TO: Gulf of Mexico Fishery Management Council**FROM:** Steve Cadrin, Independent Reviewer**DATE:** April 1, 2021**RE:** Peer Review of "The Great Red Snapper Count: Estimating the Absolute Abundance of Red Snapper in the U.S Gulf of Mexico"

In consultation with the Gulf Council, I reviewed the report "The Great Red Snapper Count: Estimating the Absolute Abundance of Age-2+ Red Snapper (*Lutjanus campechanus*) in the U.S. Gulf of Mexico" (Stunz et al. 2021). The primary objective of the review was to determine if the abundance estimate and its variance are reliable and consistent with data and population characteristics by addressing three specific terms of reference. In addition to addressing the specific terms of reference, general comments are provided on the case study and its application for stock assessment. The peer review process is being conducted in association with the Council's Standing Scientific and Statistical Committee (SSC), Special Reef Fish SSC, and Special Socioeconomic SSC (March 30 to April 2, 2021 via webinar), but my consultation is not a formal component of the Scientific and Statistical Committee's recommendations on an overfishing limit and acceptable cat

Figure 1. Red snapper abundance in the eastern and western areas of the northern Gulf of Mexico estimated from the Great Red Snapper Count (GRSC) and the SEDAR52 stock assessment (SEDAR 2018; unfished, 1870-2016 estimates, 2017-2020 projections at the overfishing limit).

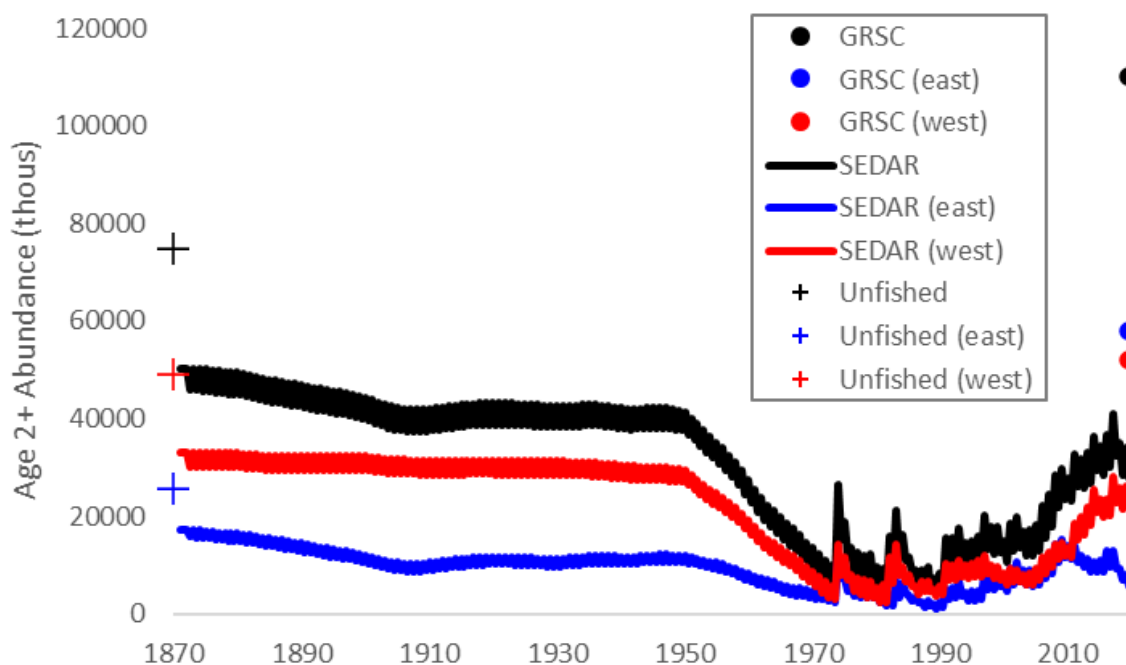
The estimate of age-2 red snapper abundance in late 2019 was 110 million with a CV of 11%. If the CV is correct, abundance estimates are appropriately reported in significant digits of 10-million. Because of the large area of uncharacterized habitat, those strata contributed the most to the stock-wide abundance estimate. As reported in section II.F.2.c (estimate reconciliation) the estimate of abundance is substantially greater than contemporary estimates from the SEDAR52 stock assessment. The stock-wide estimate of age-2+ abundance is about four times greater than the projected 2019 abundance and greater than estimates of unfished stock abundance from the SEDAR52 stock assessment (Figure 1. below; SEDAR 2018; age-2+ estimates and projections from M. Smith).

The estimated spatial distribution of the resource is relatively even (53% eastern regions, 47% western regions), which is substantially different than the spatial distribution estimated by the SEDAR52 assessment (21% eastern area, 79% western area; Figure 1). Stock assessments are typically better at assimilating data and estimating relative stock status than they are at estimating absolute stock size, but the different perspectives of spatial distribution raises concerns that the apparently even spatial distribution may result from unequal sampling efficiencies of the different sampling methods used in each region. Most hard bottom was in the Florida strata, sampled with optic methods, but most oil and gas platforms were in western region, sampled with acoustic methods. Estimates of abundance assumed 100% detection, but paired comparisons show that acoustic sampling has much lower detection. Therefore, abundance in western regions may be substantially underestimated, and including them in an integrated stock assessment may impose conflicting information on scale.
